# Work Order ID 83091

Item Name: Crosstube Turning Detail

<b>DART AEROSPACE LTD</b>	<b>Work Order:</b> 83091
<b>Description:</b> Crosstube Assembly (205/212/412 High Fwd)	<b>Part Number:</b> D212-664-141
<b>Inspection Dwg:</b> D212-664-141 Rev: D	<b>Page 1 of 1</b>

DRAWING NO. D212-664-141	TITLE XTUBE ASSY (205/212/412 HI FWD)	REV. D	DART AEROSPACE LTD ENGINEERING ORDER		D.E.O. NO. D212-664-141-D-1	SHEET NO. SHEET 1 OF 2	SCALE NTS
DRAWN	CHECKED	MFG. APPR.	APPROVED	DE APPR.			
DATE 11.04.07	DATE 11.04.11	DATE 11.04.12	DATE 11/04/12	DATE 11.04.12

D212-664-141TRN  
TURNING DETAIL

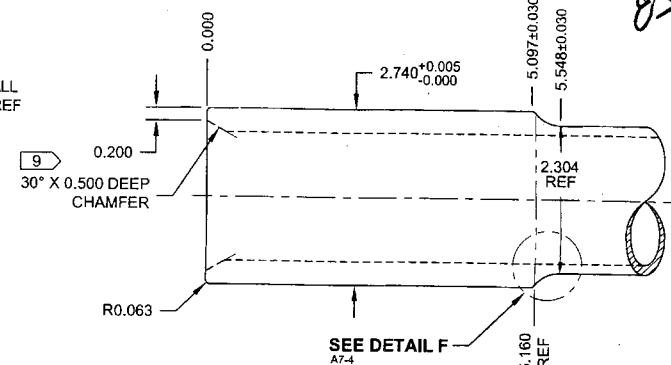
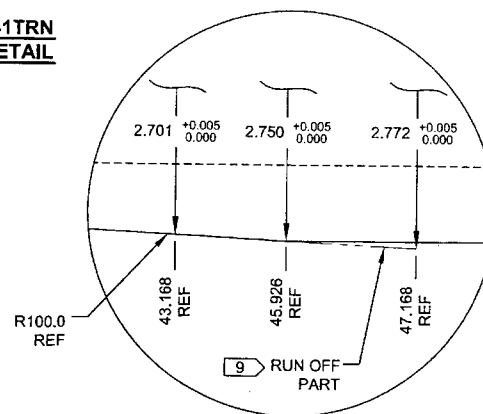
NCR: 12-1485		WORK ORDER NON-CONFORMANCE (NCR)						
DATE	STEP	Description of NC Section A	Corrective Action Section B			Verification Section C	Approval Chief Eng	Approval QC Inspector
			Initial Chief Eng	Action Description Chief Eng	Sign & Date			
12.06.04	100	Cuff is oval. Small dim = 2.736 large dim = 2.746	GP 12.06.04	Acceptable. ORIENT WITH LARGE DIM UP/DOWN IN BENDER.	<u>Star</u> 12-6-4	JW 12-6-5	GP 12.06.04	S 12/06/04

**D212-664-141/-141B  
ASSEMBLY DETAIL**

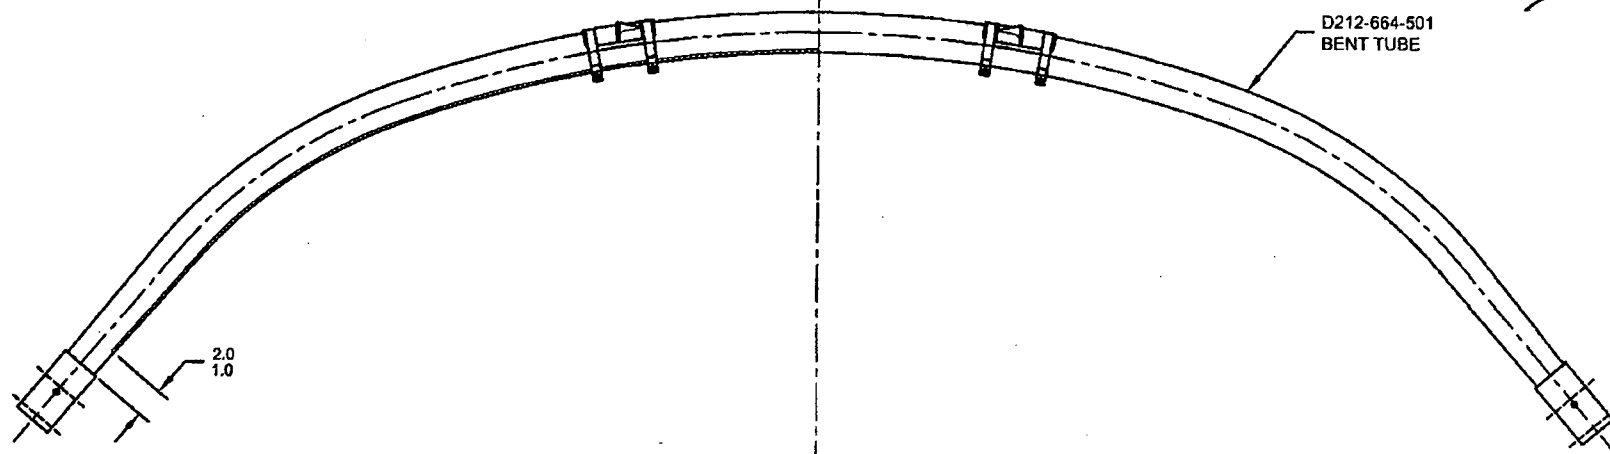
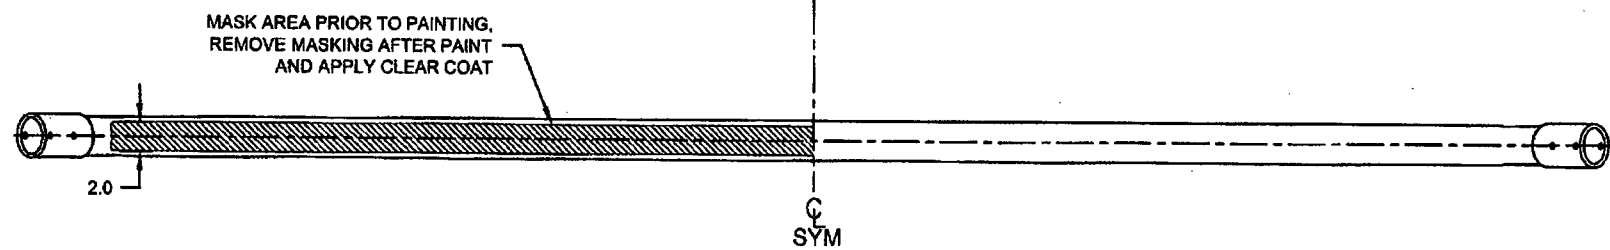
**PURPOSE:**

ADD AN INSPECTION WINDOW TO UNDERSIDE OF CROSSTUBE.

**CHANGE:**

NOTES 2 OF SHEET 1 IS AMENDED AS FOLLOWS:

**IS:**

- 2) FINISH: CHEMICAL CONVERSION COAT PER DART QSI 005 4.1  
PRIME INSIDE AND OUTSIDE PER DART QSI 005 4.2  
MASK UNDERSIDE OF CROSSTUBE AS SHOWN (HATCHED AREA) AND  
PAINT OUTSIDE PER DART QSI 005 4.2  
REMOVE MASKING AND APPLY CLEAR COAT

**WAS:**

- 2) FINISH: CHEMICAL CONVERSION COAT PER DART QSI 005 4.1  
PRIME INSIDE AND OUTSIDE PER DART QSI 005 4.2  
PAINT OUTSIDE PER DART QSI 005 4.2
